SUBJECT: Forwards Suppl 2 to XN-NF-84-72, "Large Break LOCA-ECCS Analysis W/Increased Enthalpy Rise Factor: K(Z) Curve" & revised Tech Spec Page 3.10-22, reflecting substituted K(Z) curve, per 840723 request re Cycle 10.

H. B. ROBINSON STEAM ELECTRIC PLANT, UNIT NO. 2  
DOCKET NO. 50-261/LICENSE NO. DPR-23  
SUPPLEMENTAL REQUEST FOR LICENSE AMENDMENT - CYCLE 10  
REVISED K(Z) CURVE

Figure 3.10-3

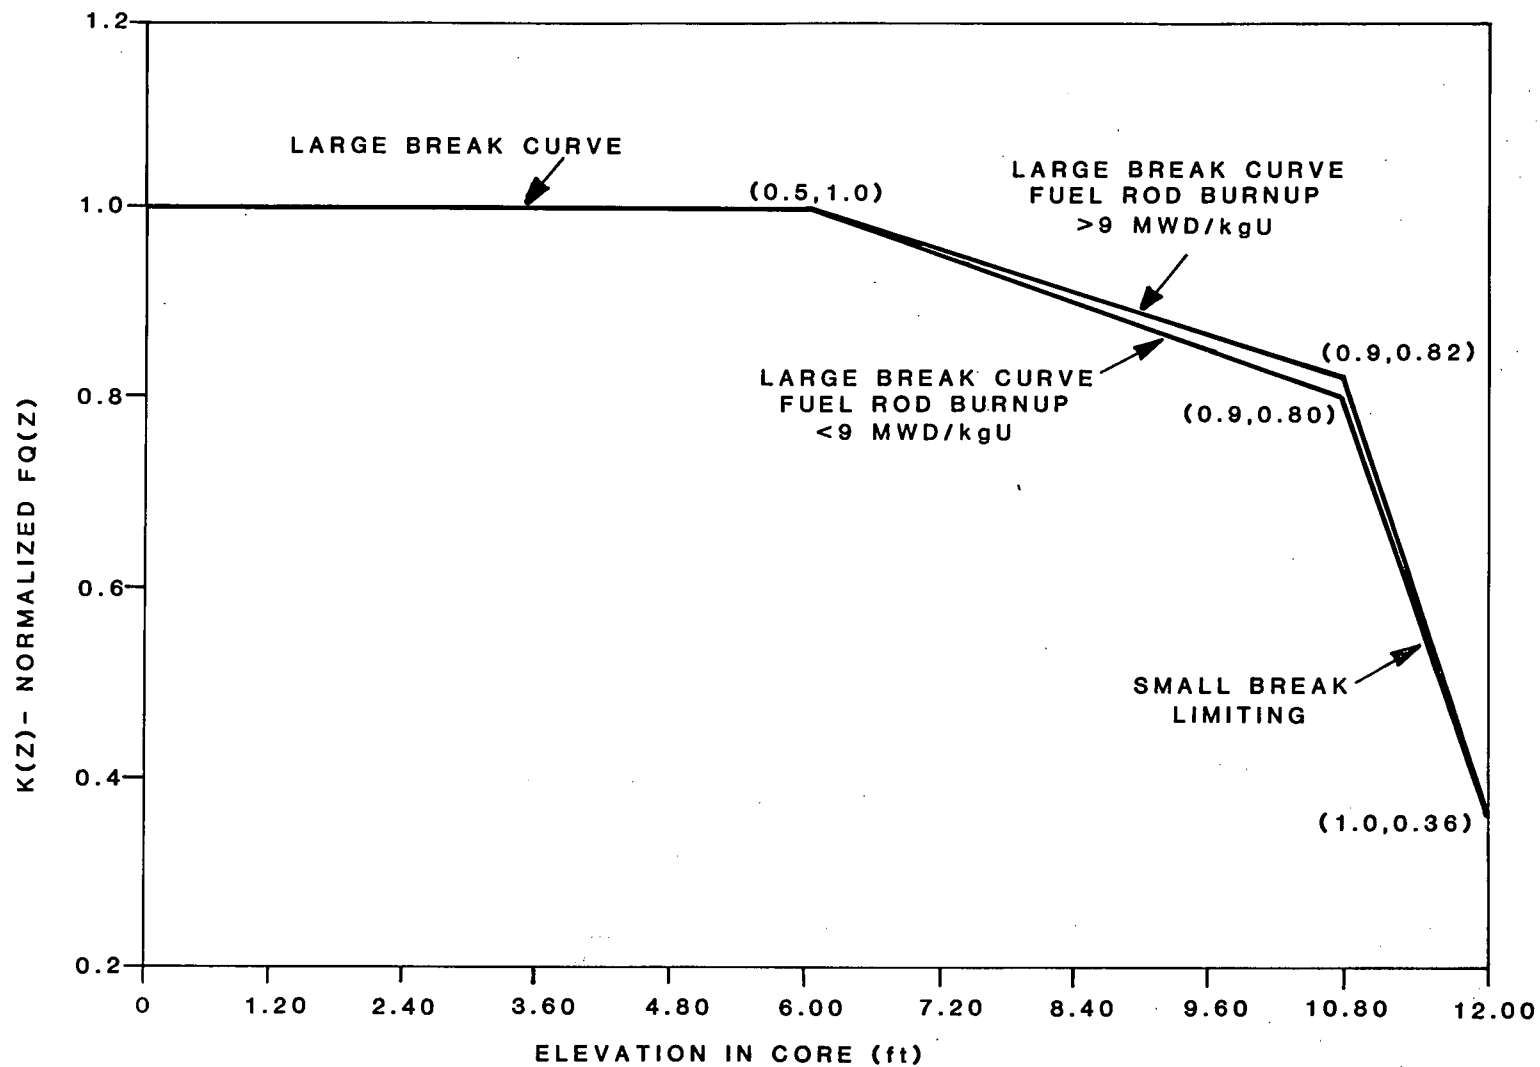
While verifying the previously submitted K(Z) Curve, CP&L/Exxon determined that with an  $F_{AH}$  of 1.65 at a burnup of approximately 9MWD/KgU, HBR2 would be required to turn on the Axial Power Distribution Monitoring System (APDMS) for the remainder of Cycle 10. Since the operation of this system is inconvenient, time consuming and has other operational impacts, a new burnup dependent curve was developed for the elevation above the six-foot level. The new curve will limit the operational impacts by reducing the need to implement APDMS while retaining adequate margins of safety.

While confirming the analyses which produced the original K(Z) Curve, it was determined that in the event of a LOCA it would be possible to exceed a peak clad temperature (PCT) of 2200°F. Reanalyses have produced a more conservative curve which meets the criterion for PCT remaining below 2200°F during LOCA events. Because the new curve is more conservative than the original, CP&L believes prenoticing is not required.

Please find attached a revised page 3.10-22 which replaces the previous page 3.10-22 submitted with our July 23, 1983 TS request. Should you have any questions regarding this matter please call Mr. Sherwood R. Zimmerman at (919) 836-6242.
